CITY OF CODY
PLANNING, ZONING AND ADJUSTMENT BOARD
TUESDAY, APRIL 8, 2014
CITY HALL COUNCIL CHAMBERS @ 12:00 NOON

**CITY OF CODY
PLANNING, ZONING AND ADJUSTMENT BOARD
STAFF REPORT**

MEETING DATE:	APRIL 8, 2014	TYPE OF ACTION NEEDED	
AGENDA ITEM:		P&Z BOARD APPROVAL:	X
SUBJECT:	RIVERSIDE CEMETERY COLUMBARIUM GARDEN, FILE SPR 2014-09	RECOMMENDATION TO COUNCIL:	
PREPARED BY:	TODD STOWELL, CITY PLANNER	DISCUSSION ONLY:

Riverside Cemetery: Columbarium Garden

REVISED PLAT OF
RIVERSIDE CEMETERY SECOND ADDITION
BEING PART OF THE BROWN ADDITION TO THE CITY OF CODY

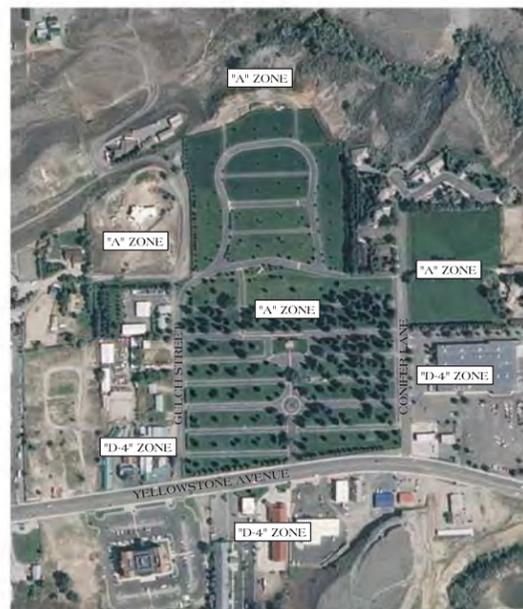
The columbarium will be located in an area previously identified as eight rectangular blocks with twelve cremation lots each. The lots are unsold. The proposed columbarium utilizes a different configuration than the plat of record. Both the cemetery's attorney and the city attorney are looking into what is needed, if anything, to map out the columbarium niches. (This is something new for all of us.) It is the city planner's thought that the property owner is responsible to provide an updated plat to reflect the changes to the cemetery lots.

1. Add the required tactile warning strips to the ADA ramps next to the road.
2. Unless direction from the city attorney is otherwise, the property owner is responsible for filing an updated plat to reflect the changes for the columbarium units.

SHEET
C-1

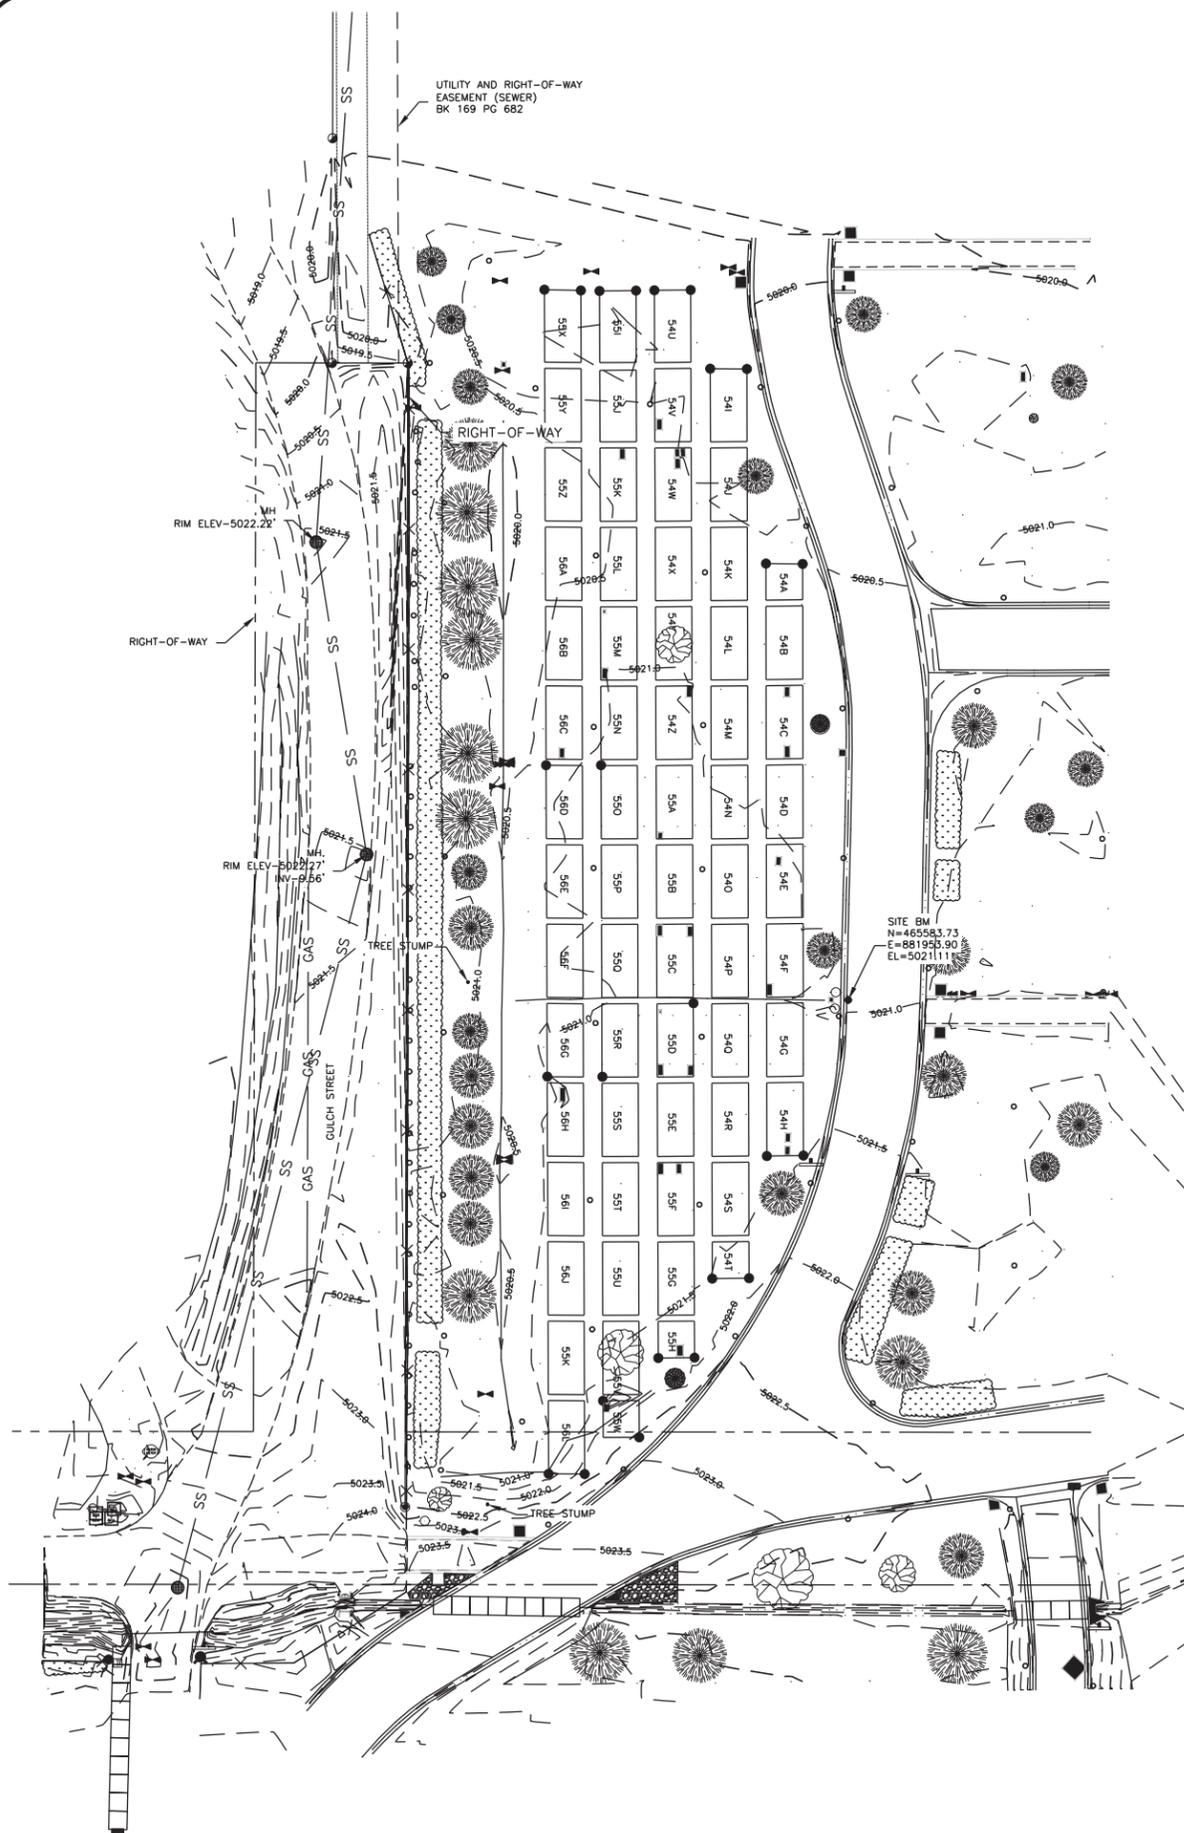
Sheet C-1 identifies utility easements and rights-of-way in the vicinity. The project stays outside of all identified easements. Modifications to the cemetery irrigation system are identified on the plans.

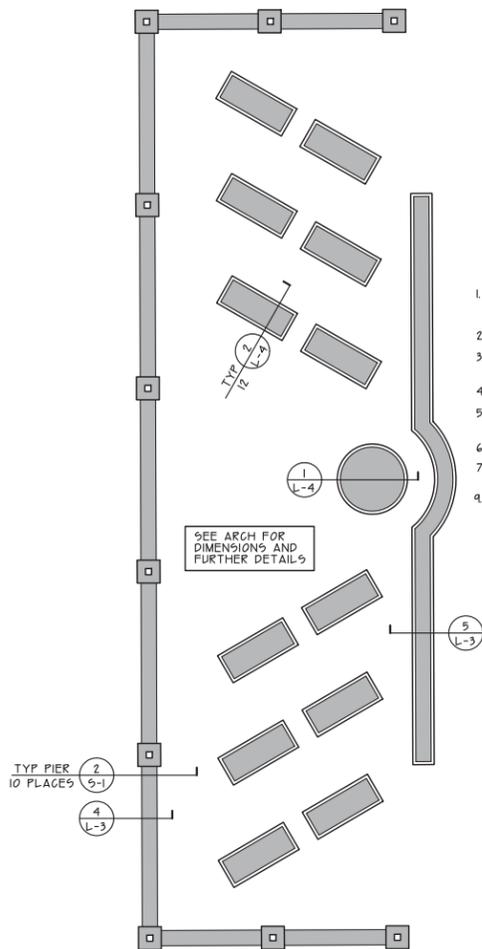
The site is designed for ADA access. Only one modification/addition to the ADA access has been identified at this point—tactile warning strips (truncated domes) will be needed at the curb cut next to the roadway.

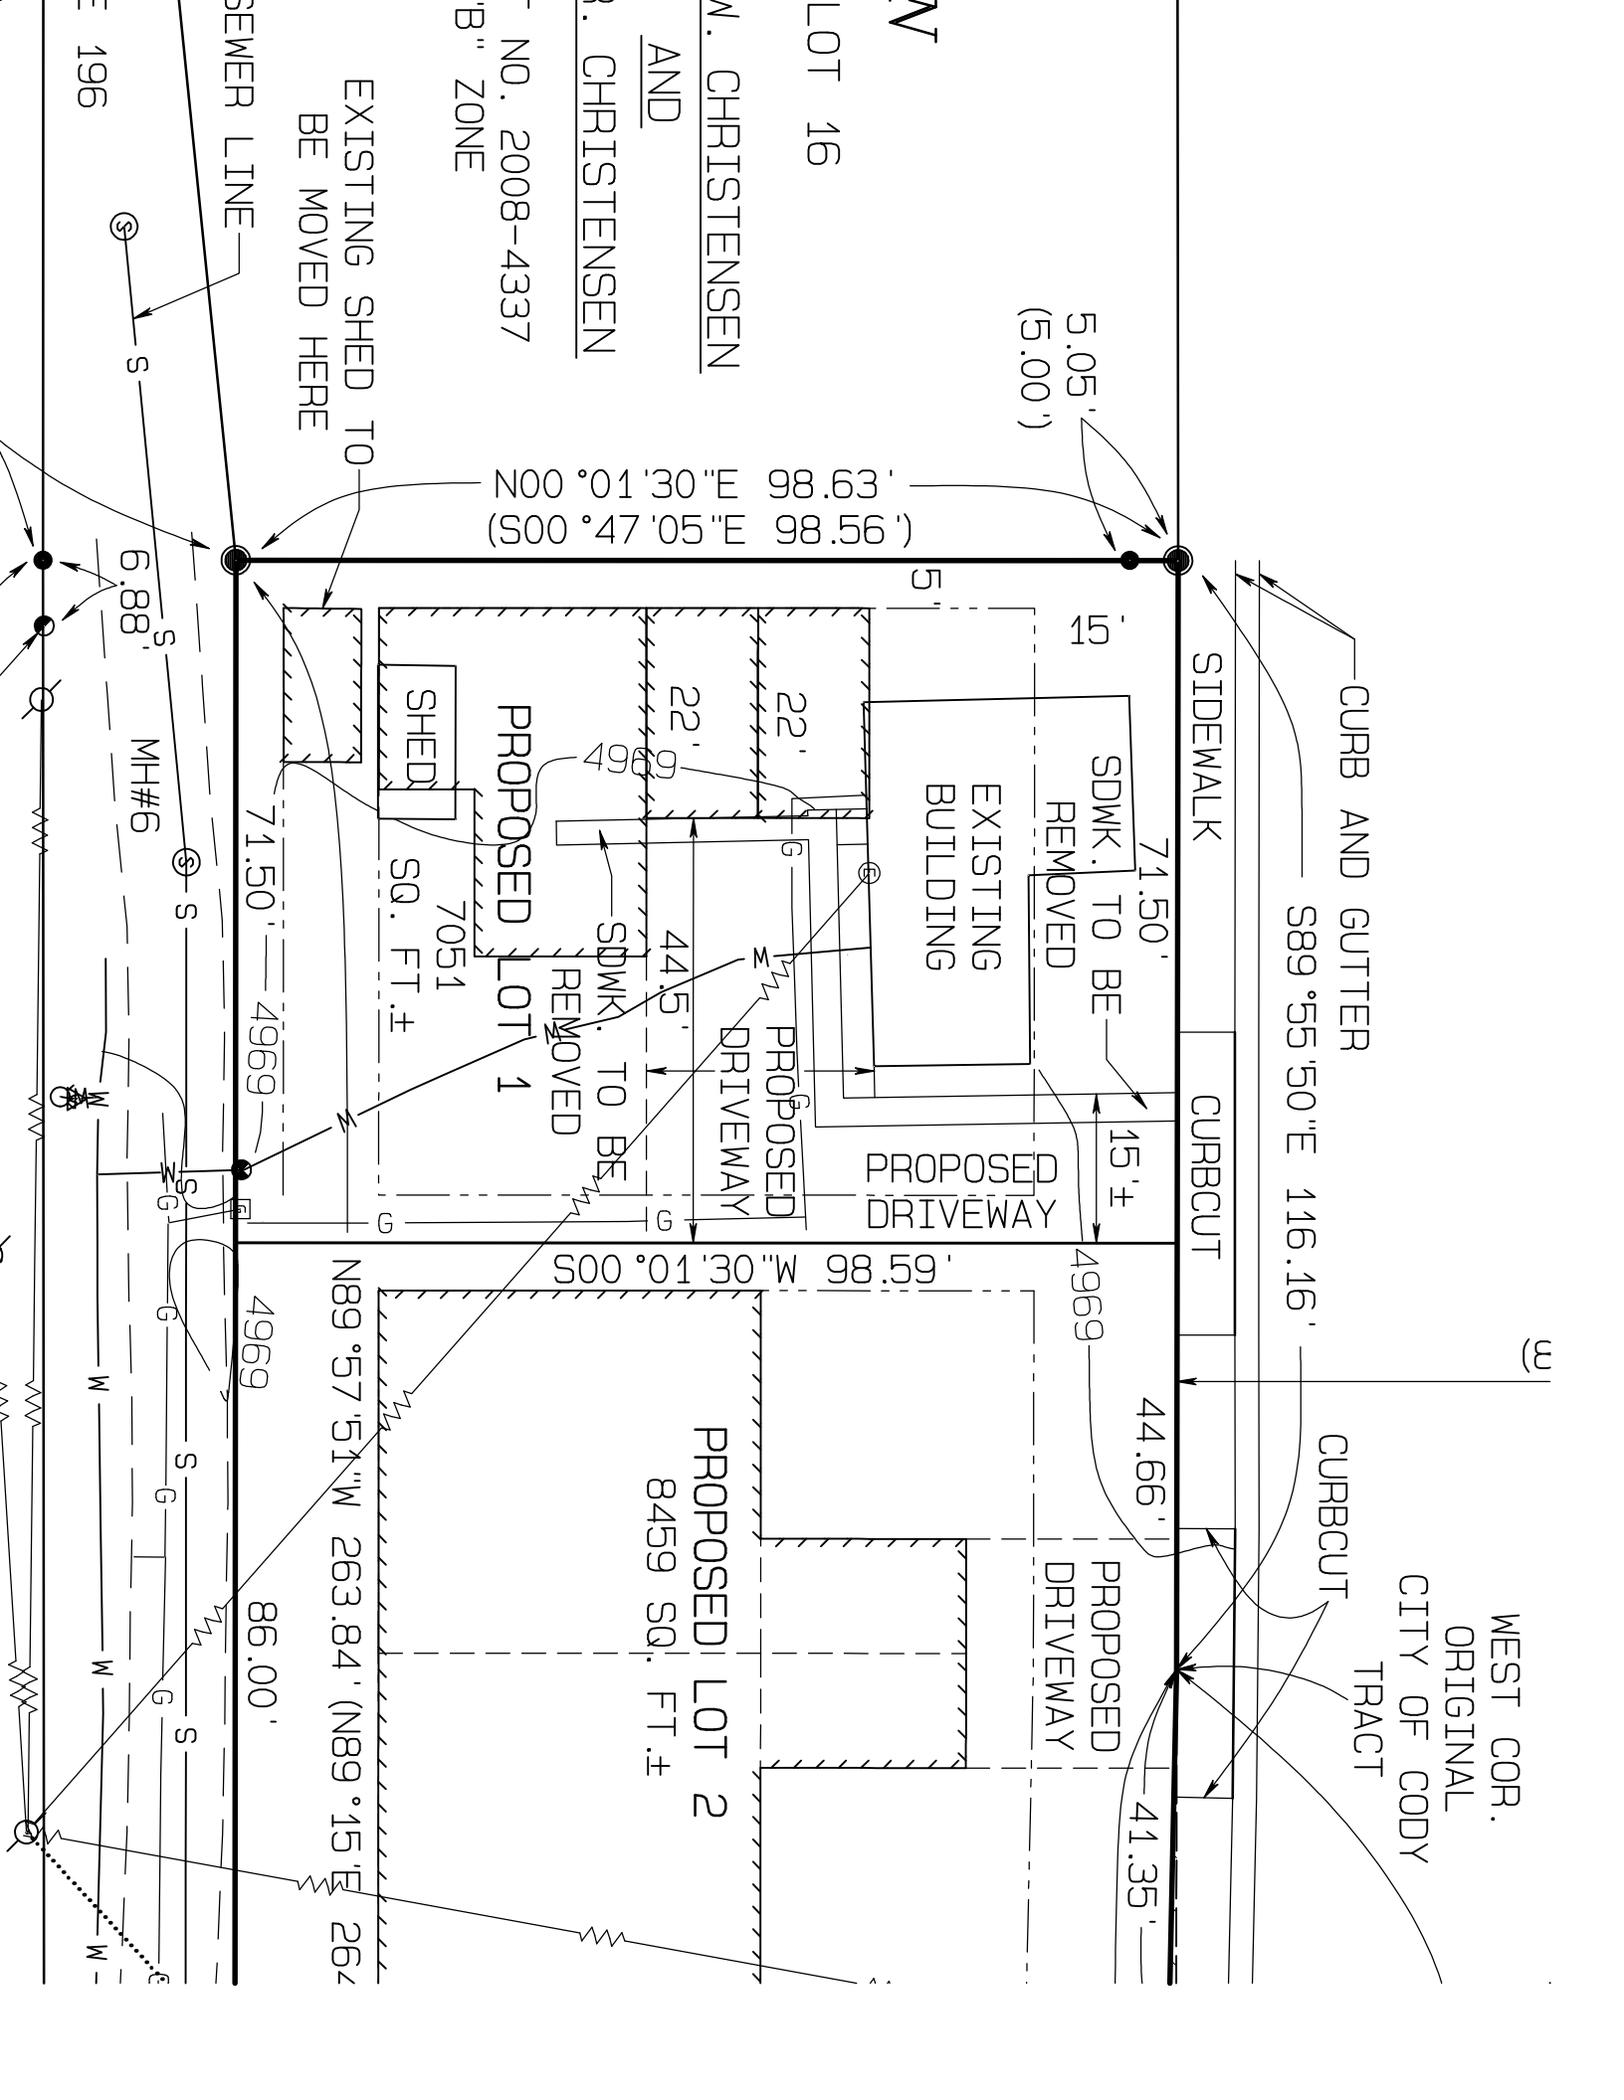
In addition, the 696 square foot size of the building is less than required for new dwellings under Section 10-11-1(A), which requires a minimum size of 864 square feet per dwelling for new permanent dwellings. The structure is also considered nonconforming in this respect as well. The building was apparently a dwelling prior to use as a church. It is noted that the proposed addition is currently shown as slightly less than 864 square feet (approx. 796?). The new dwelling unit will need to meet the minimum size requirement, so modifications to the plan will be needed.

Staff is admittedly concerned about the extent of the nonconformity—approximately ten feet into the fifteen-foot setback. Any passerby can clearly identify it as the only “out of place” building in the neighborhood. Additionally, although the siding is new, the underlying structure is 71 years old and is of unknown condition to staff. I question whether the existing building will last as long as the portion that will be built. If not, approval of the current request would likely lead to a future request to reconstruct the older portion, and guess what, the only place it would fit is five feet from the front property line.

From a regulatory standpoint, if there is a time to correct the nonconformity it would be now, before additional expense is put into it and while the building is most readily modified.

Staff is still thinking through this one. If approved, I do not see the need for any specific conditions, as everything would be covered through the building and utility plan review.
